BOBS CREEK
STREAM MITIGATION SITE

RE: Bobs Creek Monitoring (DMS Project # 92879, Contract # D09023S)
Final Year 4 (2019) Annual Monitoring Report

Axiom Environmental, Inc. (AXE) is pleased to provide you with two hard copies and one cd of electronic files for the Final Bobs Creek Year 4 (2019) Annual Monitoring Report. We received your comments via email on January 8, 2020 and have addressed them as follows.

FIGURE 2B

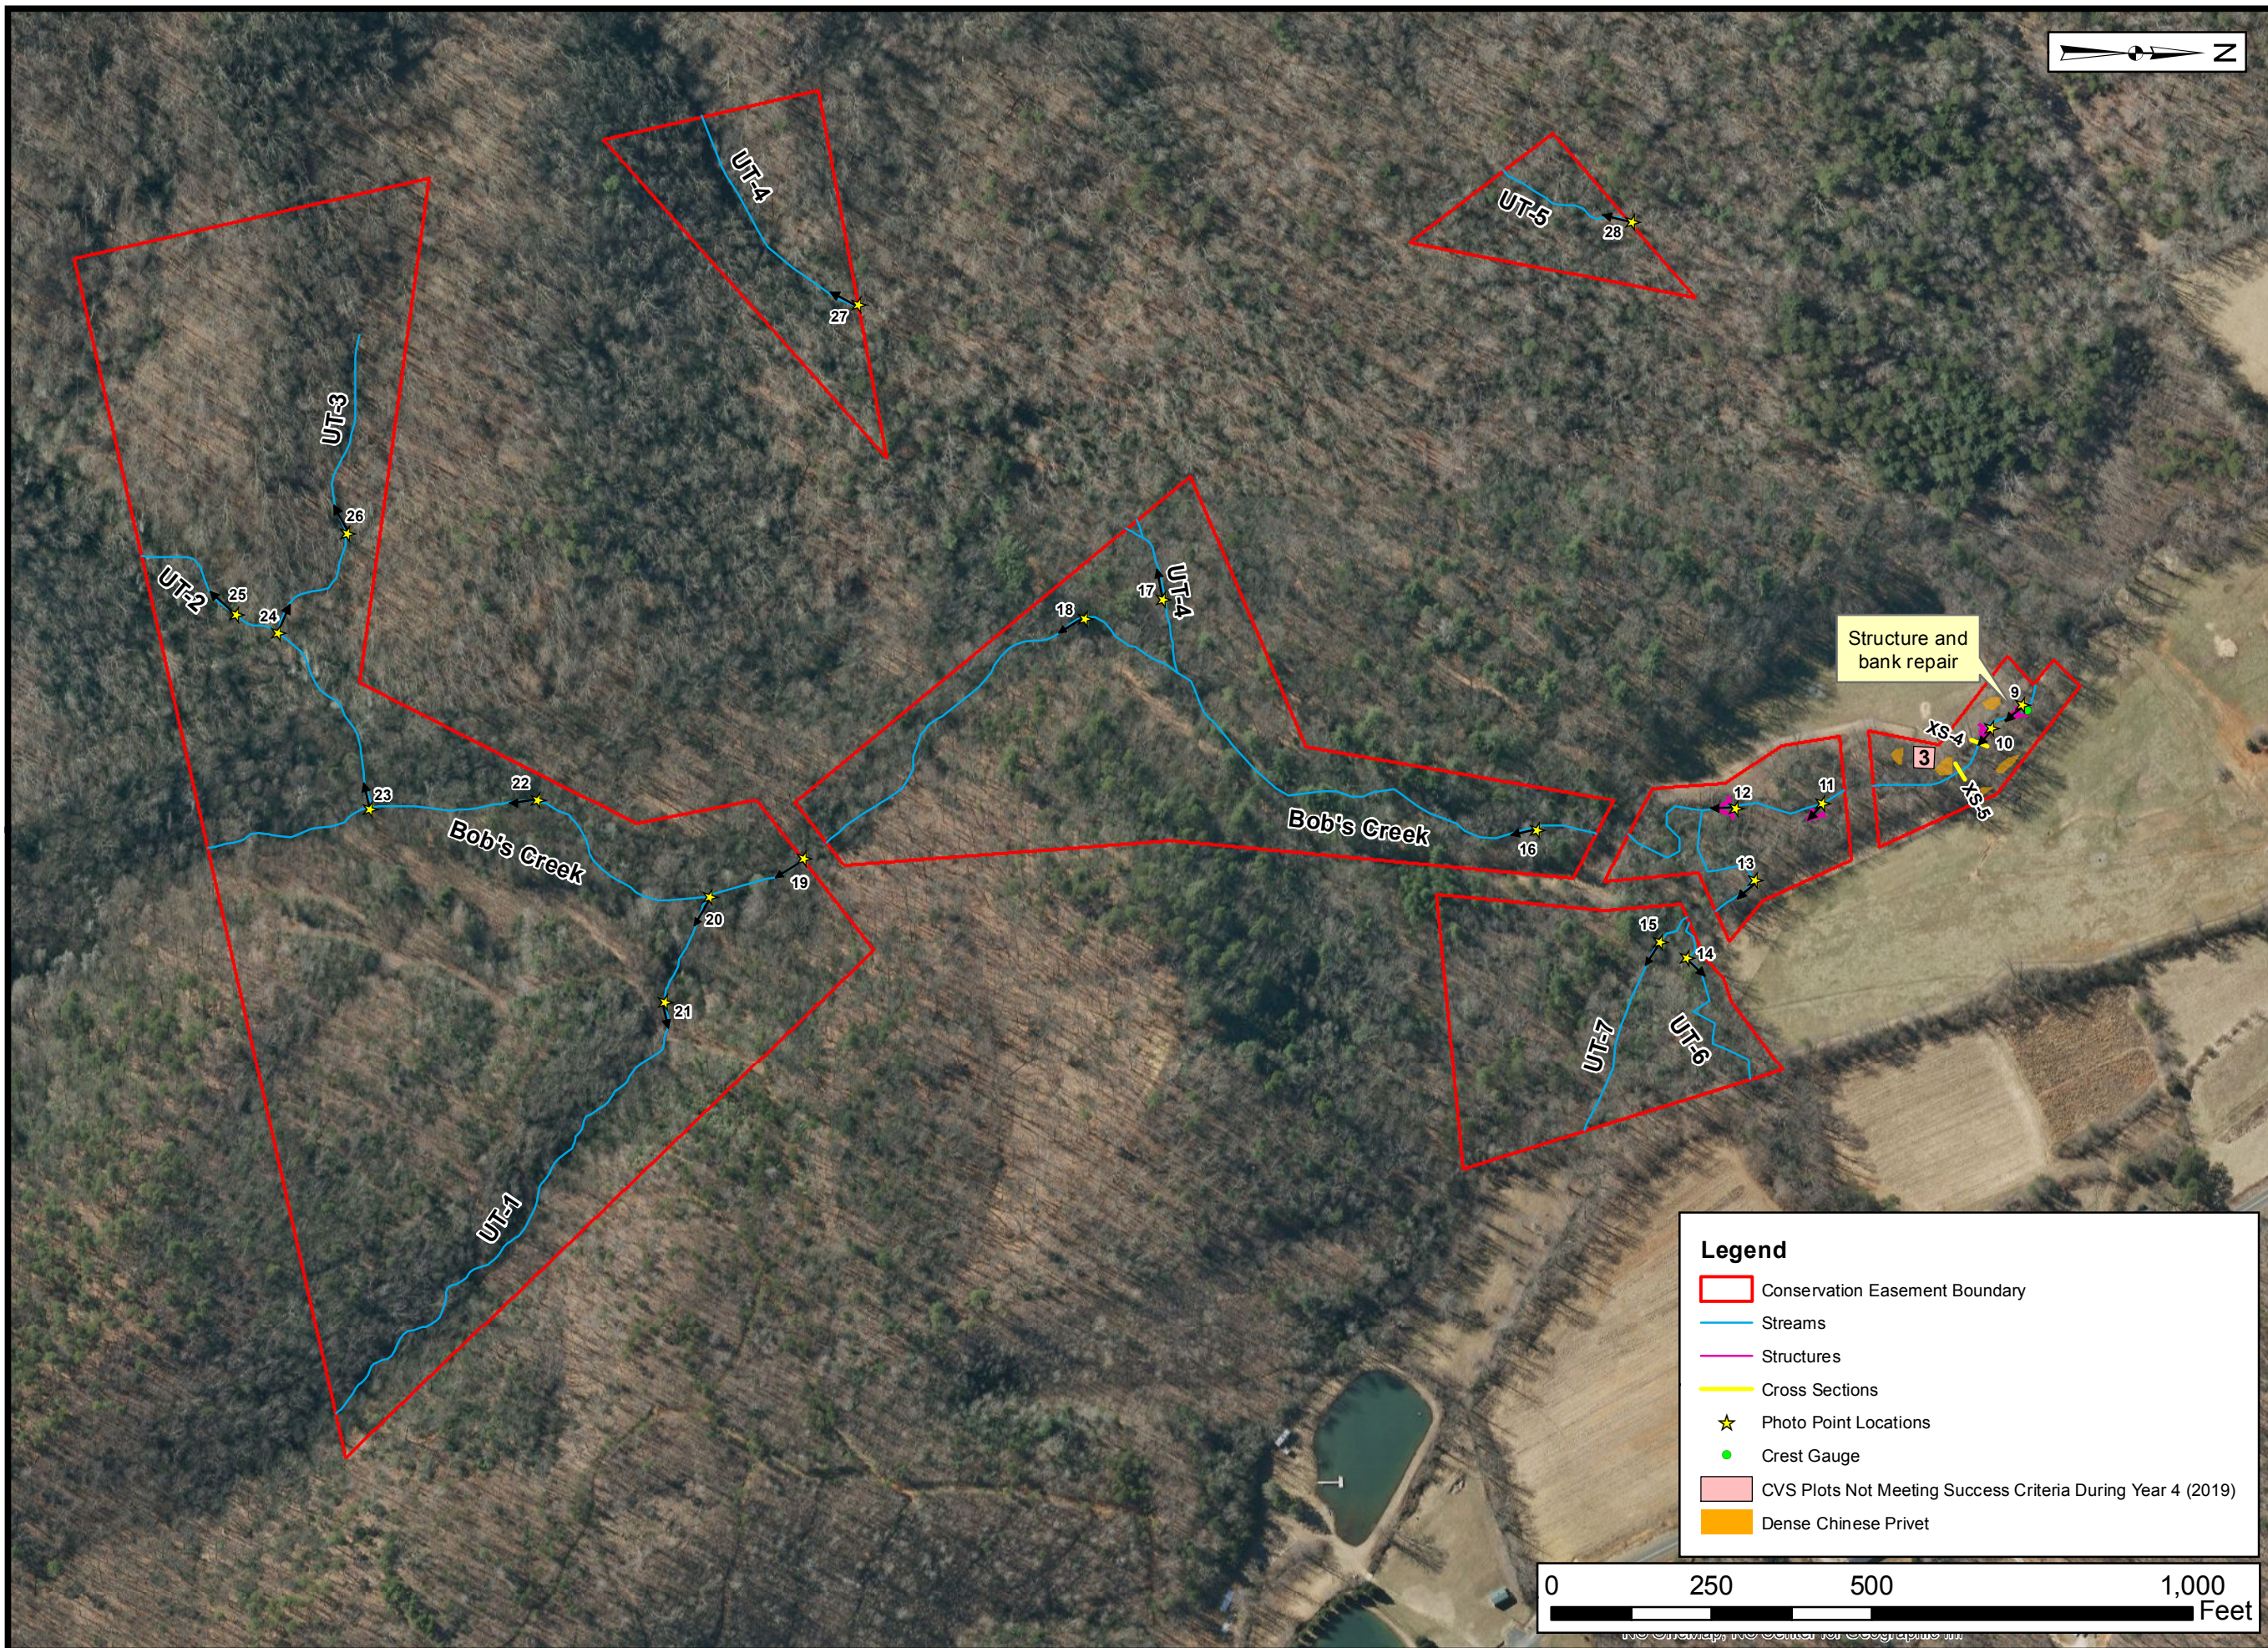
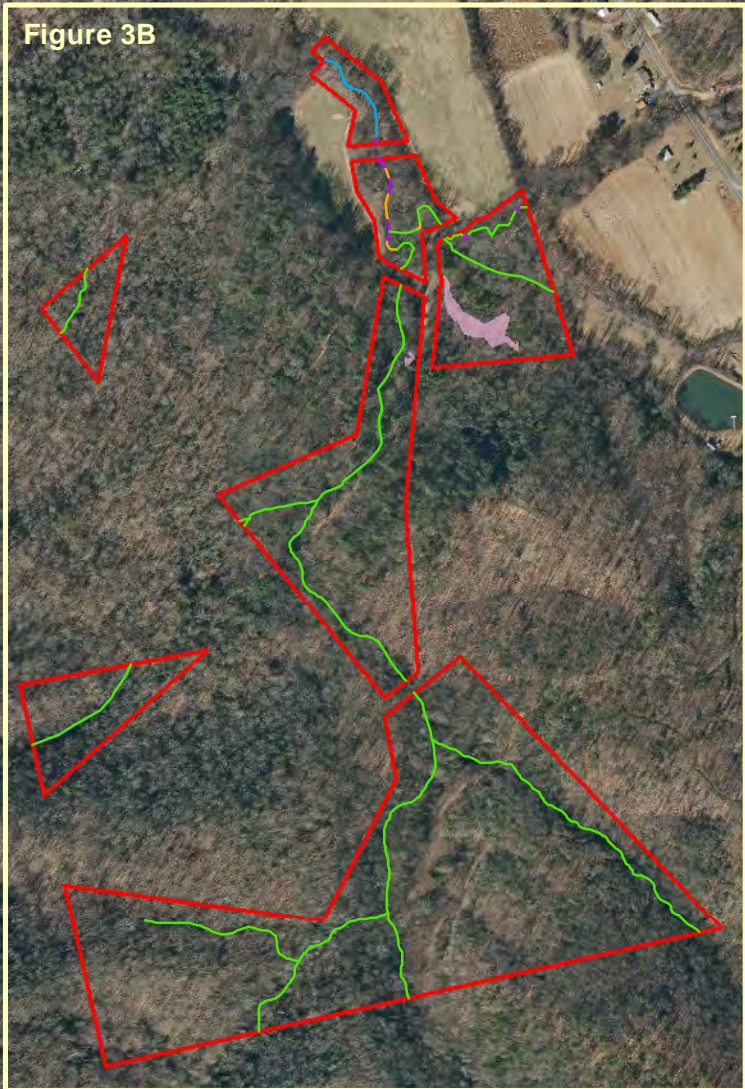
- CCPV: Please add location of repaired structure to CCPV and callout (see attached map)
A callout was added to point out the repaired structure on figure 2B.
